Landscape Referral Response

Application Number:	DA2023/1536
Date:	01/05/2024
Proposed Development:	Alterations and additions to a Place of Public Worship (Bahai Temple)
Responsible Officer:	Olivia Ramage
Land to be developed (Address):	Part Lot 52 DP 1152609 , 173 Mona Vale Road INGLESIDE NSW 2101

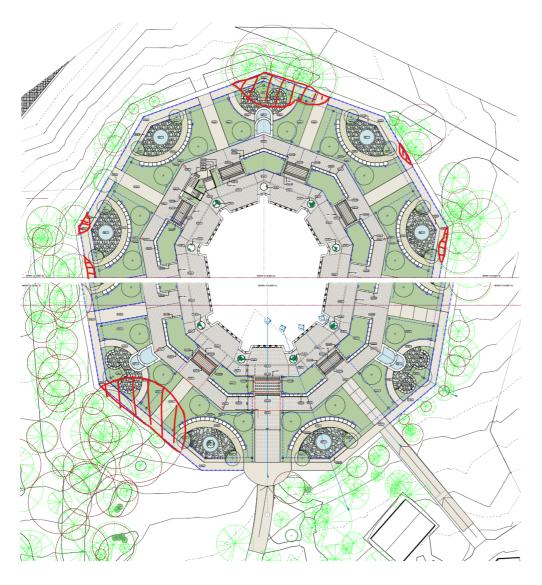
Impact assessment is required for all trees within 5 metres of the proposed works. Many trees may suffer tree protection zone encroachment which has not been identified or discussed in the AIA. These works include, but are not limited to, fill (and associated batters as seen in section 2 and 4), construction of paths, construction of walls, stormwater drainage lines etc. The Arborist shall assess the impact to all trees within 5 metres of the works and provide comments so the appropriate tree protection measures can be implemented. If the Arborist does note foresee any impact to these trees,

this shall be outlined in the AIA.

For example (potential tree protection zone encroachment areas):

Landscape Referral can continue their assessment upon receipt of further information.
